Staff Report

To: Salt Lake City Planning Commission
From: Katia Pace, 801-535-6354, katia.pace@slcgov.com
Date: November 18, 2020
Re: PLNPCM2020-00288, PLNPCM2020-00289, PLNSUB2020-00347, 833 Emeril Townhomes - Planned Development, Design Review and Preliminary Subdivision

PLANNED DEVELOPMENT, DESIGN REVIEW & SUBDIVISION

Elevation view of front façade showing a height of 30' 3".

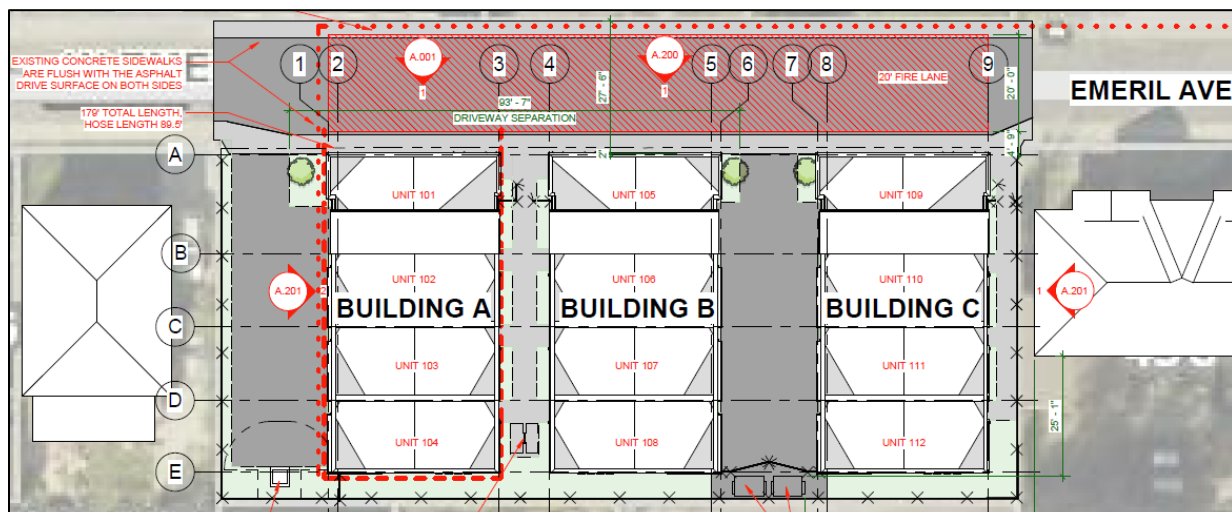
According to Fire code, a structure that is over 30 feet in height requires an aerial apparatus access road with a 26-foot clear width, that width does not include sidewalks. The overall proposed height of this development is 30 feet 3 inches and Emeril Avenue has only 20 feet of road width and approximately 3 feet of sidewalk on each side. In order to approve this project, the fire department would require two Alternative Means and Methods applications for an automatic fire sprinkler system in the townhomes and the second to provide a dual chamber smoke detection in the townhomes. Staff recommends approval with a condition that the applicant will comply with all required department comments and conditions.

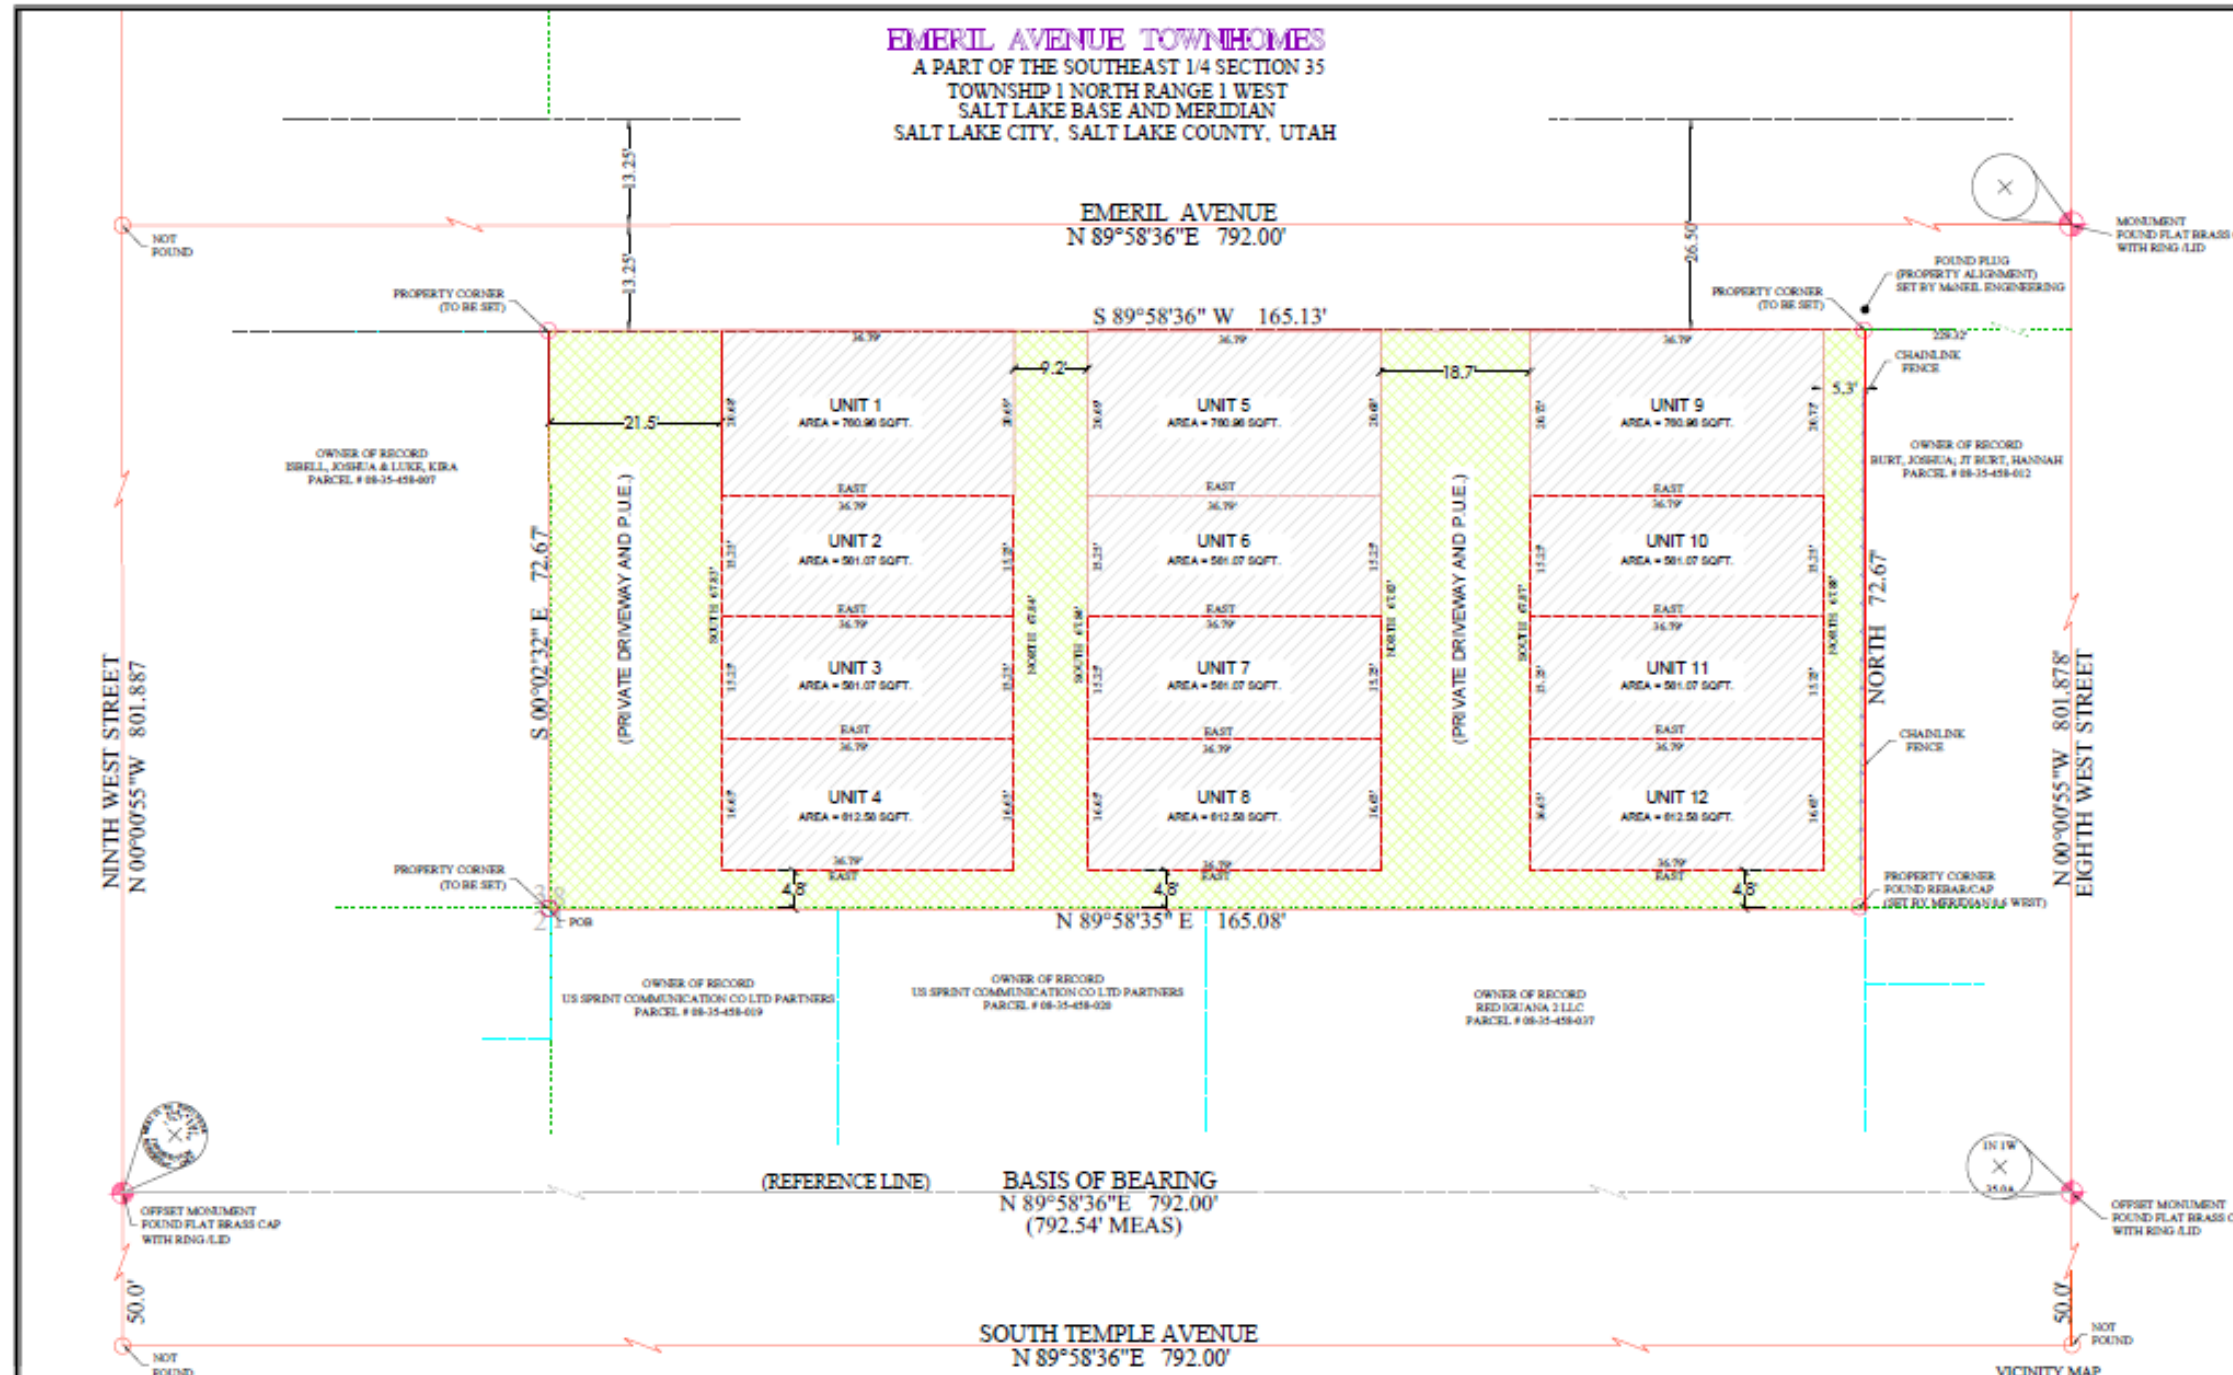
5. Since there are multiple signors, there will need to be additional notary acknowledgements added for them.

6. The notary laws changed May 9, 2017, so the wording is different. Please have the applicant revise the wording in the body of the Notary Acknowledgment to match the attached example.

I am guessing that the “Acceptance by Legislative Body” and “Planning Commission Approval” blocks are signature blocks. Those two blocks need to be deleted and the standard signature blocks need to be added at the bottom on the plat. Those are as follows: (a) City Public Utilities (water/sewer); (b) City Planning Director; (c) City Engineer; (d) City Attorney; (e) Mayor (or the City); (f) Salt Lake County Health Department (has to say County, not Valley); and (g) Salt Lake County Recorder.
